Access Compliance Report

Public Rights-of-Way

(Curb Ramps)

Intersection ID: 13212	Main Street: SAM_RYBURN_WALK	Cross Street: ARMORY_DR	Location: SW
ADA ID: 49FC667584B1	Ramp Type: Para	Initial Pass/Fail: Fail	Overall Compliance: No
Severity Score: 13.75			
Codes/Mitigation Info/Possible Solution		Field Measurements/Component Compliance

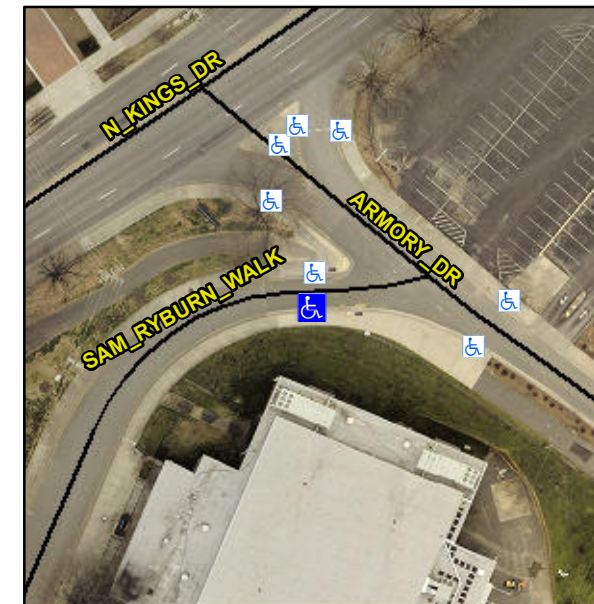
RT RP < 5%

PROW/ADA:

R304.3.2, R304.5.3

Remove & Replace Entire Ramp.
